UNITED STATES PATENT AND TRADEMARK OFFICE

Office Action Summary

10/518,907

DETAILED ACTION

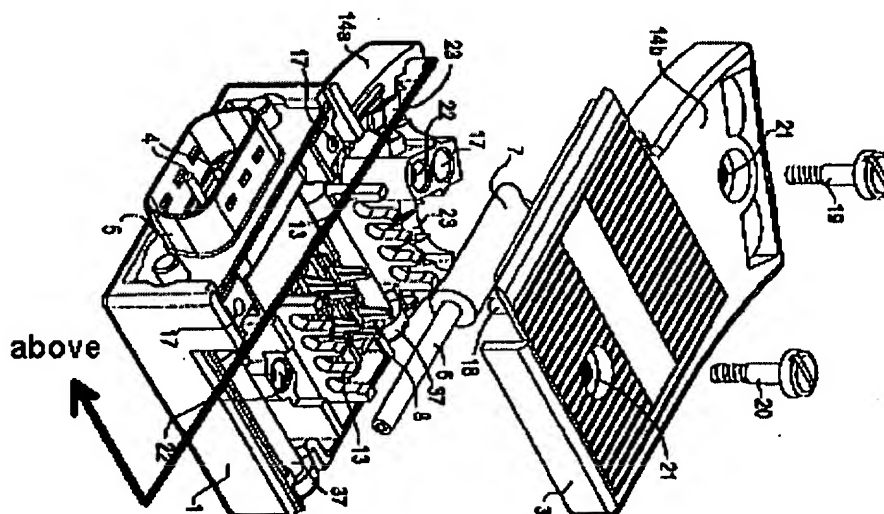
In response to Applicant's argument that Embo does not disclose the plug contact protruding above the holder (16), please see the following figure.
